**UNITED STATES
NUCLEAR REGULATORY COMMISSION**
WASHINGTON, D.C. 20555-0001

**SUBJECT: MCGUIRE NUCLEAR STATION, UNITS 1 AND 2 – STAFF ASSESSMENT OF
RESPONSE TO 10 CFR 50.54(f) INFORMATION REQUEST – FLOOD-
CAUSING MECHANISM REEVALUATION (CAC NOS. MF3623 AND MF3624)**

STAFF ASSESSMENT BY THE OFFICE OF NUCLEAR REACTOR REGULATION

RELATED TO FLOODING HAZARD REEVALUATION REPORT

Figure 3.1-1. Locations of Reservoir Developments on the Catawba River (Derived from Duke, 2014a)

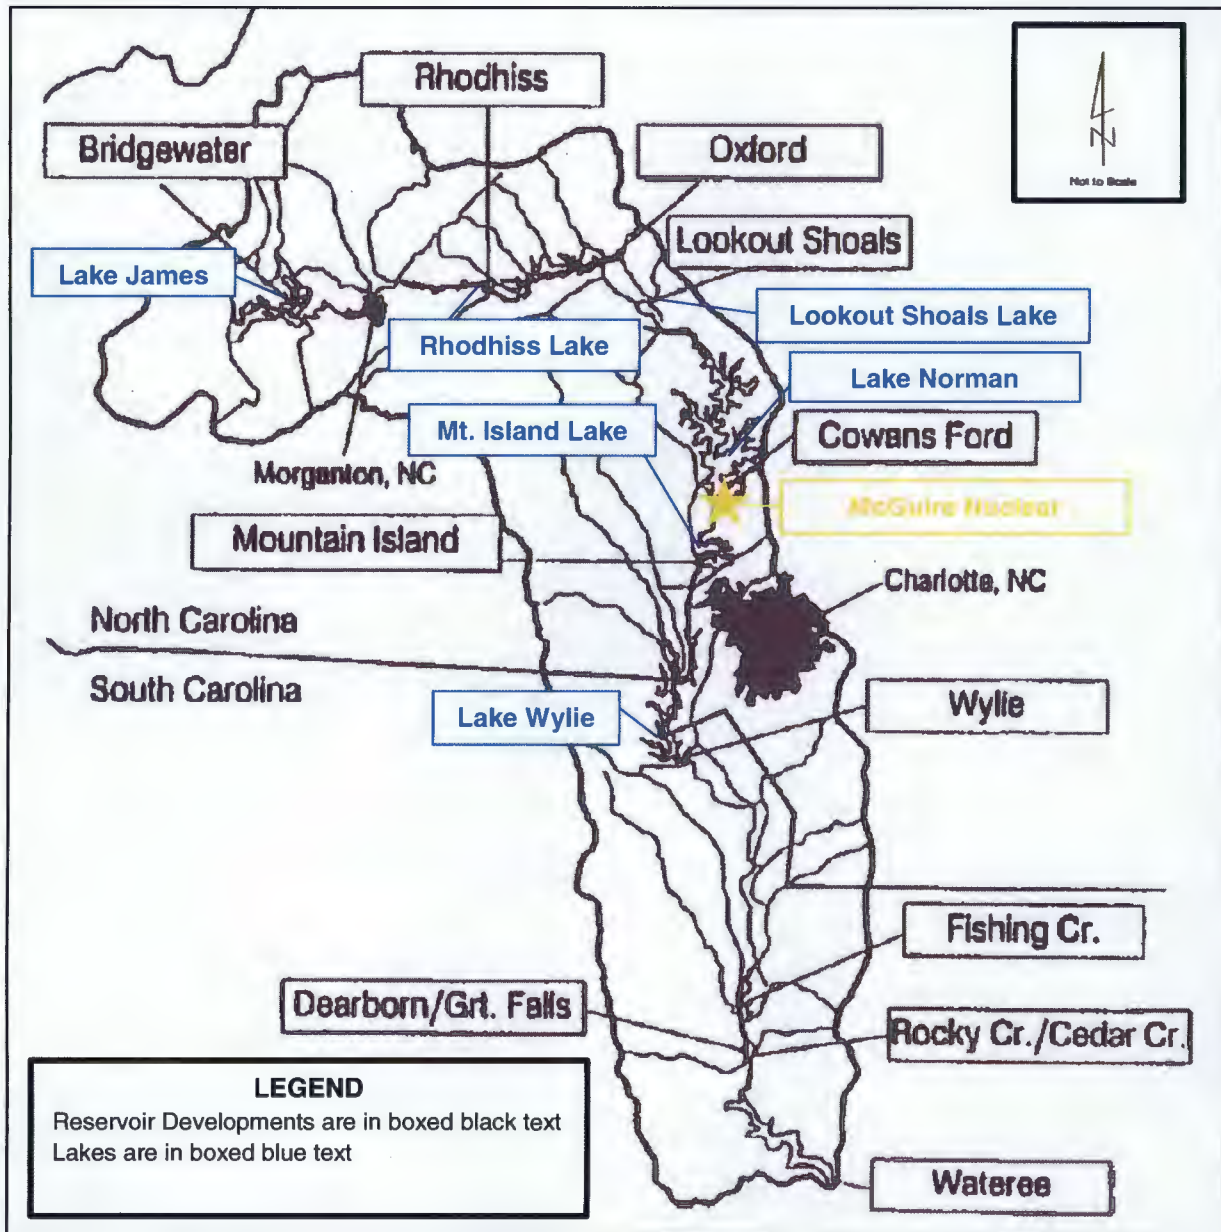
The licensee stated in its FHRR that the standby nuclear service water pond (SNSWP) is a safety-related impoundment formed by damming of a small tributary immediately south of the McGuire yard. The SNSWP dam, on the west side of the SNSWP, has a crest elevation of 747 ft (227.7 m) MSL. The SNSWP dam also has a 1.5 ft (0.5 m) parapet wall for a total elevation of 748.5 ft (228.14 m) MSL. The SNSWP has a normal full pond water elevation of 740 ft (225.6 m) MSL and a surface area of 34.9 acre (0.14 km²). The tailrace of the Catawba River is situated at lower elevation than McGuire, with a maximum predicted spillway flow tailwater elevation of 698.5 ft (212.90 m) MSL (see Figure 3.1-1) (Duke, 2014a).

Figure 3.1-2. McGuire Nuclear Station Structures and Hydrologic Features (derived from USGS, 2016)

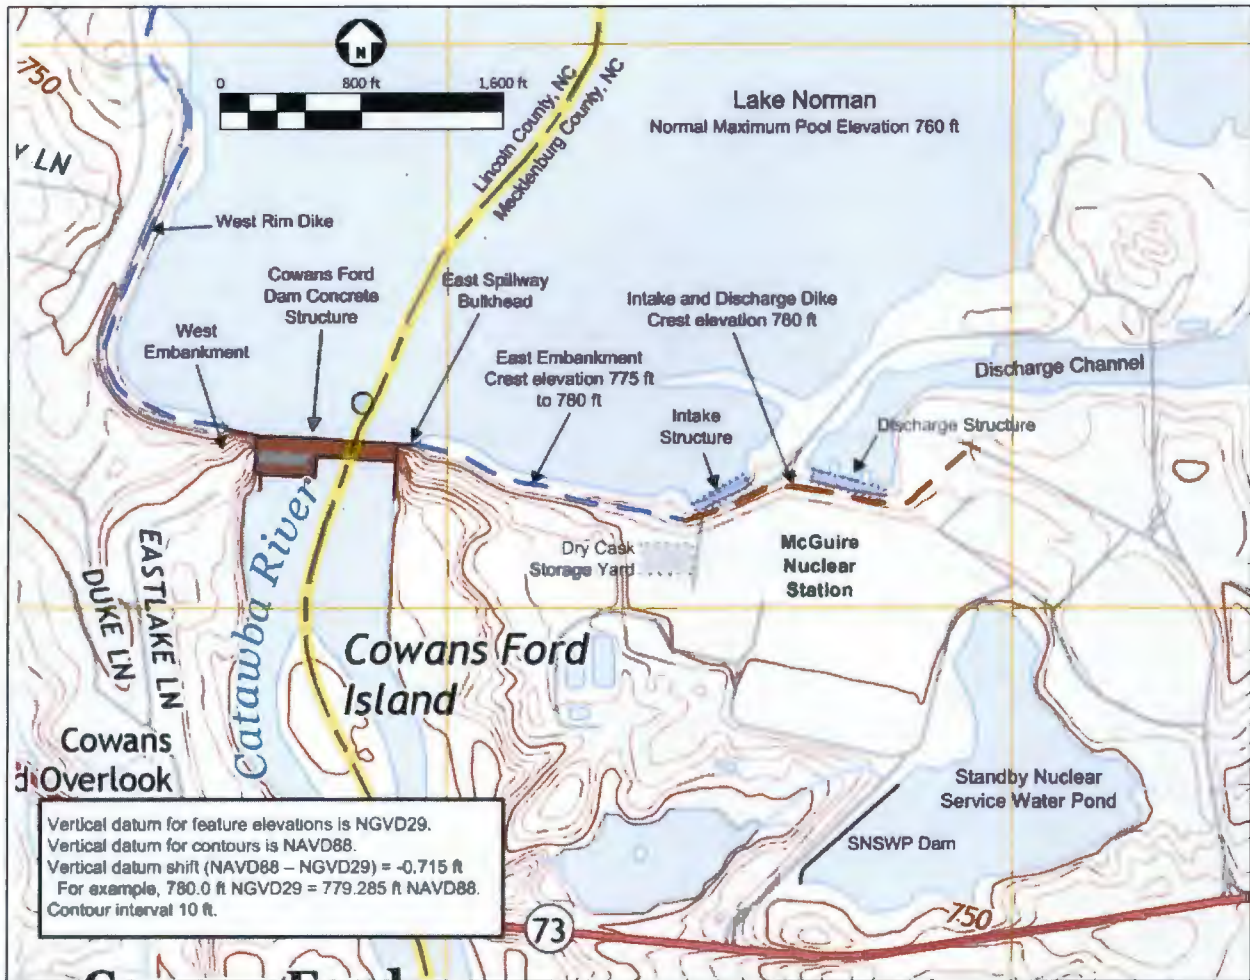
MSL northeast of the McGuire Yard. The intake and discharge dike has a crest elevation of 780 ft (237.74m) MSL, and protects the McGuire yard from flooding from the north. The intake structure, which takes cooling water from Lake Norman, is adjacent to the intake and discharge dike. The discharge structure is located immediately east of the intake structure, and discharges water back to Lake Norman through the discharge channel (see Figure 3.1-2).

The licensee determined the 2-D model's extent by security barriers, the intake and discharge dike, and ground surface sloped away from the site (see Figure 3.1-2) (Duke, 2015). On the north and northwest sides of the site, the intake and discharge dike serves as the boundary. On the east and northeast sides of the site, the security barriers serve as the model boundary. On the south and west sides of the site, the boundary of the model corresponds to where the ground surfaces sloped away from the site (Duke, 2015).
